CITY PROJECT NO. 14079
CONTRACT NO. 8709

ADDENDUM #1- 5/17/2024
REVISED THE
FOLLOWING:
TITLE SHEET
GI2-GI5, PD1-PD2, PD5-
PD6, P1-P2, P5-P6, U2-U6
REMOVED THE
FOLLOWING:
GI2 AND GI6

REVISION #1- 8/15/2024
REVISED THE
FOLLOWING:
EC4, EC6, GI1, GI3-GI5,
PD2-PD6, P2-P6, U4-U5,
W1, X4-X5, X7, X9, X12

REVISION 2: 3/21/25
REVISED THE
FOLLOWING:
P2, P3, PD2, PD3, U1, U2,
U3, U7

14079		MADISON, WI		CONTRACT NO: 8709	
DONCASTER DRIVE PLAN & PROFILE		DONCASTER BEVERLY DANBURY RECONSTRUCTION		M:\DESIGN\Projects\14079\CAD\Streets\14079EN-PnP.dwg	
14079		P-5		P-5

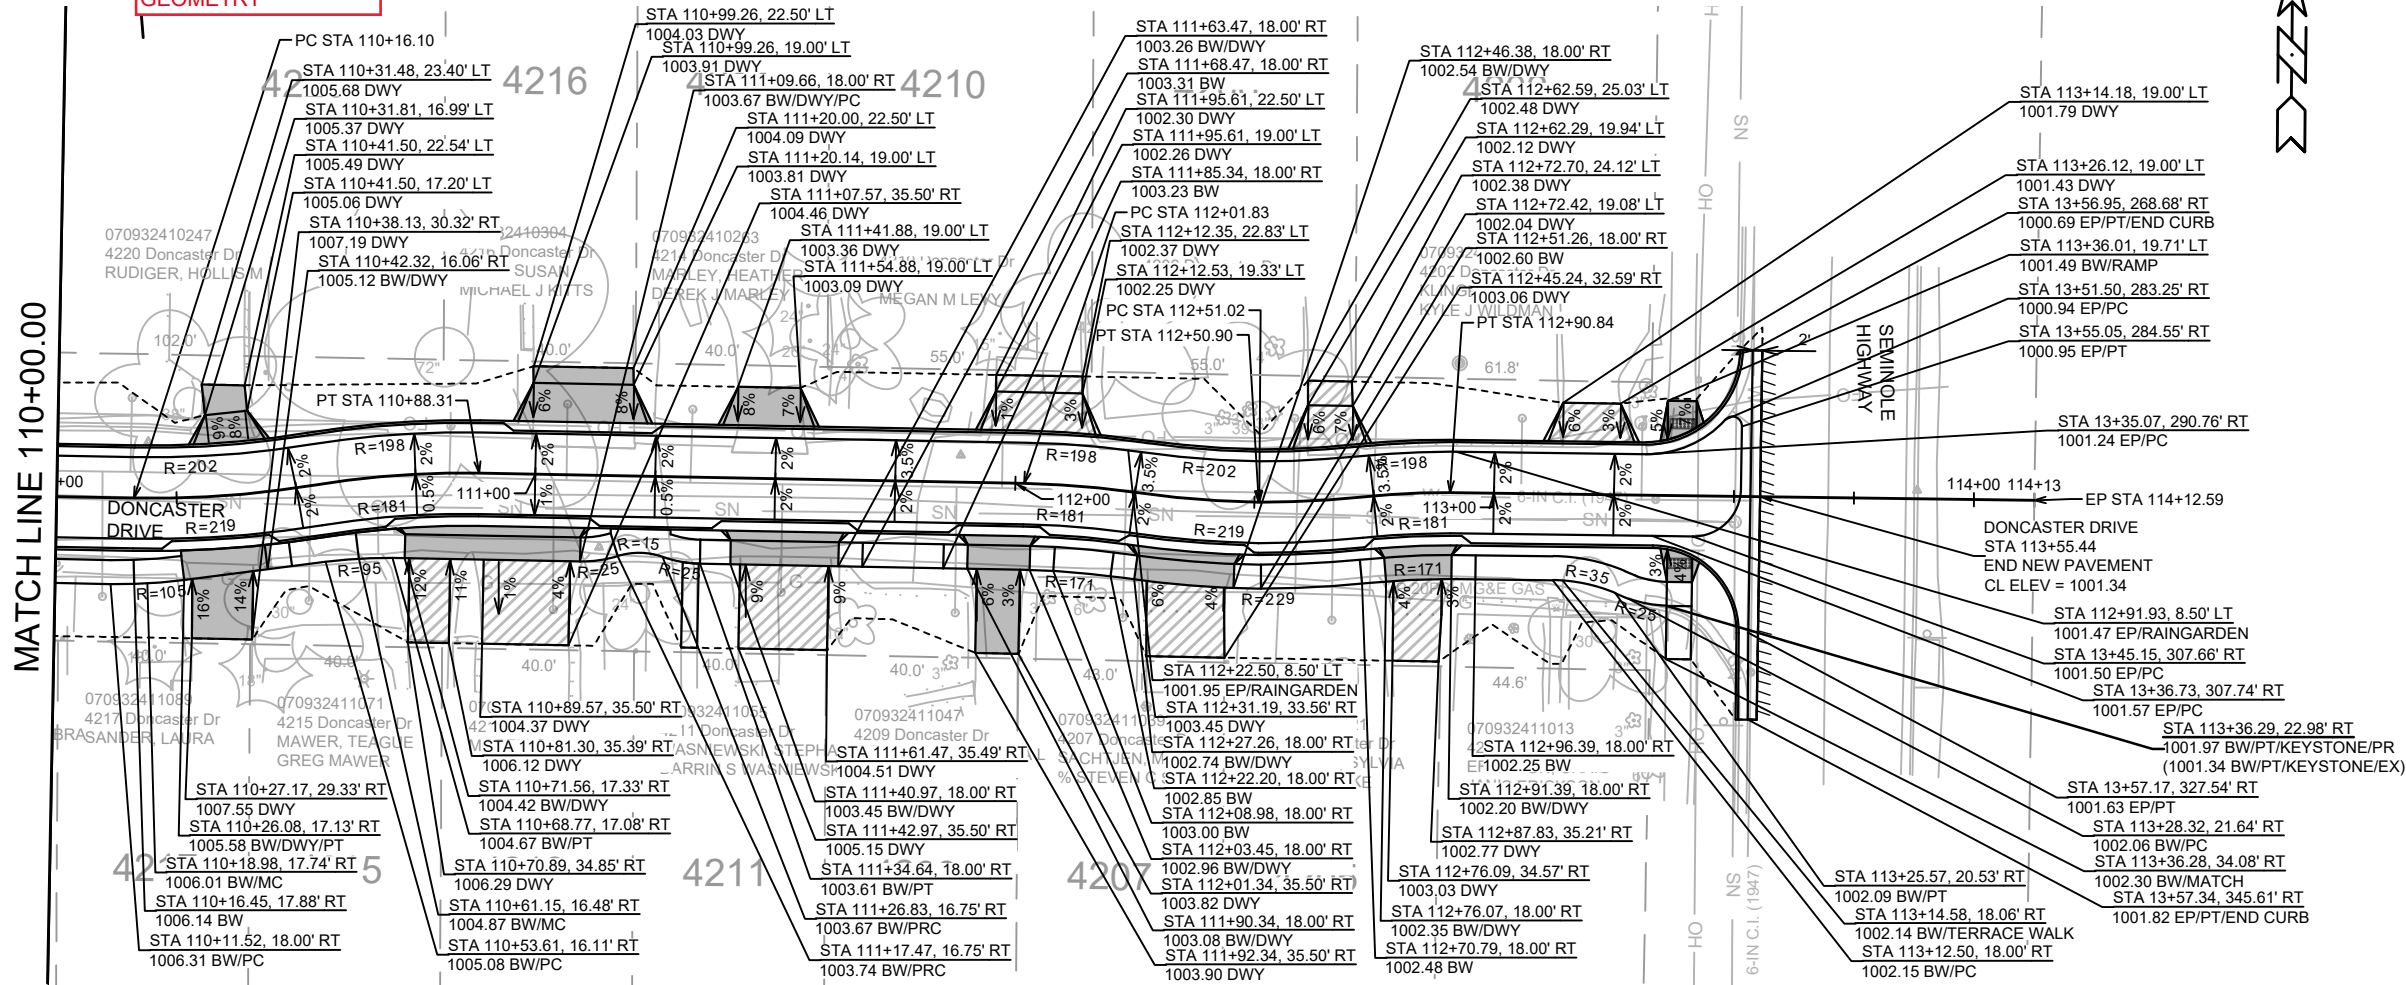
REVISION 1:
UPDATED DRIVEWAYS
TO MATCH LATERAL
GEOMETRY
